8. Well Name and No.
PETE MORROW 2T9. API Well No.
30-045-32463-00-S110. Field and Pool or Exploratory Area
BASIN FRUITLAND COAL

DJR Operating, LLC requests permission to Plug & Abandon the subject well according to the attached procedure, Current & Proposed Wellbore Diagram and Reclamation Plan.

Plug and Abandonment Procedure (Group B)

BLM FLUID MINERALS Geologic Report

DJR Operating, LLC
Proposed Wellbore Diagram

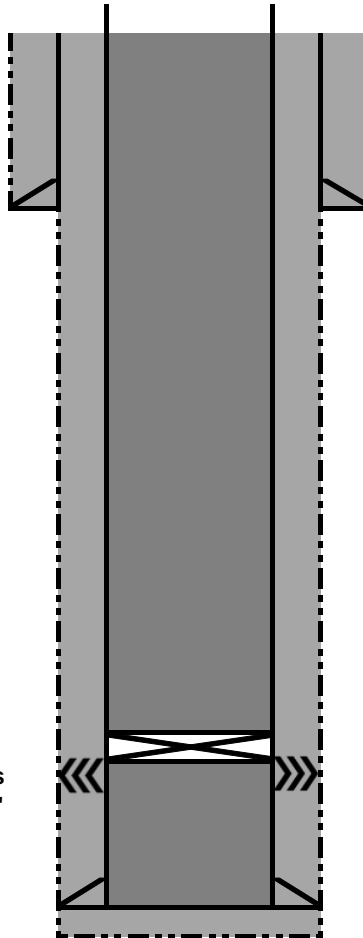
- The proposed plugging plan, if executed as presented, will adequately protect the freshwater sands in this well bore.

- Please ensure that the tops of the Pictured Cliffs and Fruitland formations as well as the entire Ojo Alamo aquifer, identified in this report, are isolated by proper placement of cement plugs. This will protect the freshwater sands in this well bore.
